REQUEST FOR AMENDMENT  
FACILITY OPERATING LICENSE NO. DPR-70  
SALEM GENERATING STATION  
DOCKET NO. 50-272

Ref. LCR 77-12A

Public Service Electric and Gas Company hereby submits proposed changes to Facility Operating License No. DPR-70 for Salem Generating Station, Unit No. 1. This change request relates to Environmental Technical Specifications (Appendix B) of the Operating License, and pertains to the selection of different sampling depth for several river monitoring locations.

FIGURE 2 VERTICAL TEMPERATURE STRUCTURE,  
15 DECEMBER 1977, FLOOD TIDE

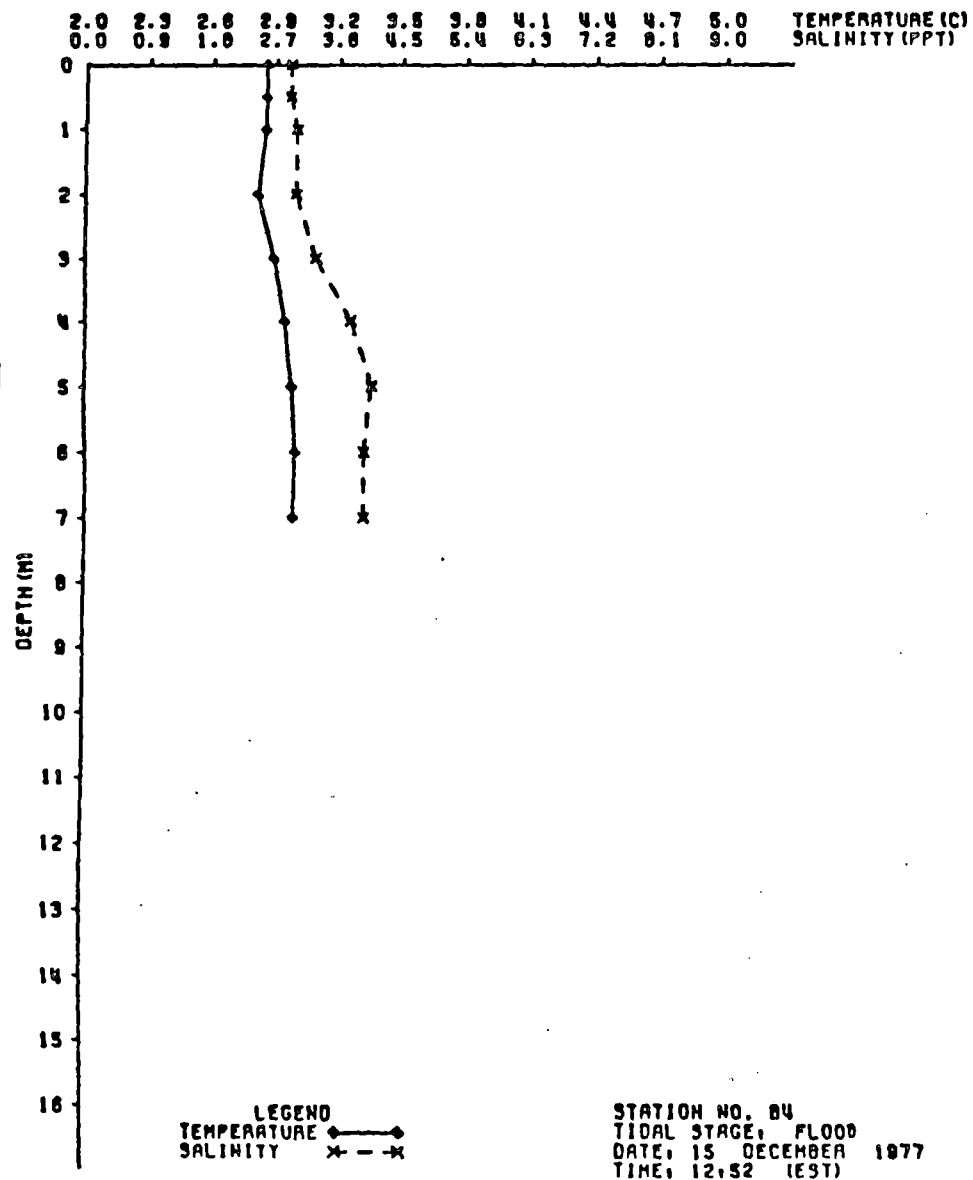
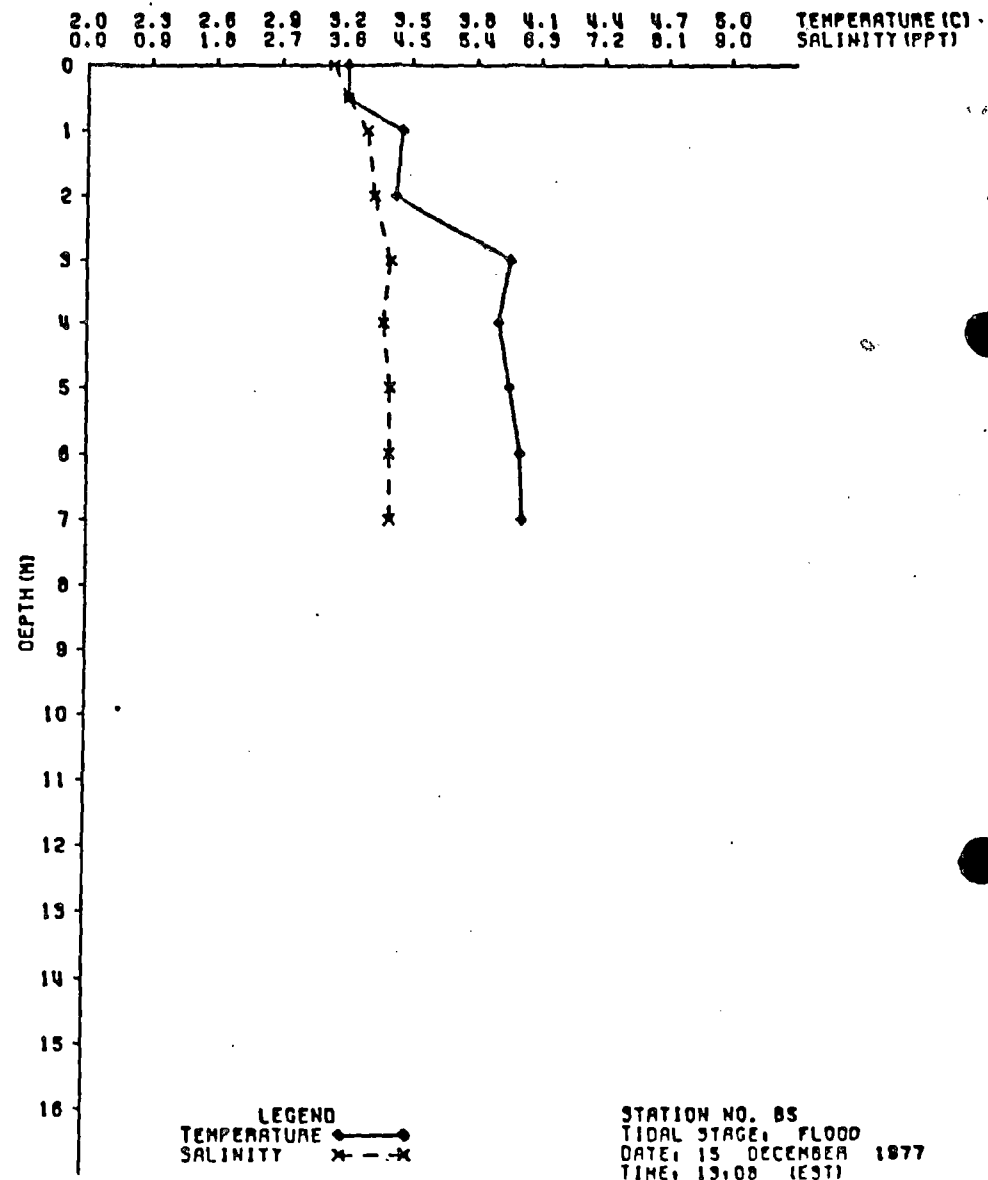
As can be seen in Figures 2 through 5, the vertical temperature distribution (and the assumed distribution of plume constituents), is nearly uniform, except for the ebb tide condition in July during which higher temperatures were observed near the surface (between 0 and 2 meters depth).

Therefore, although under most conditions, the plume appears to be well mixed, particularly outside and downstream of the mixing zone, it is reasonable to revise that sampling depth to approximately 5 feet. The licensee requests that the NRC approve this depth for all sampling outside and downstream of the mixing zone (Sections 3.1.1.1 through 3.1.1.4).
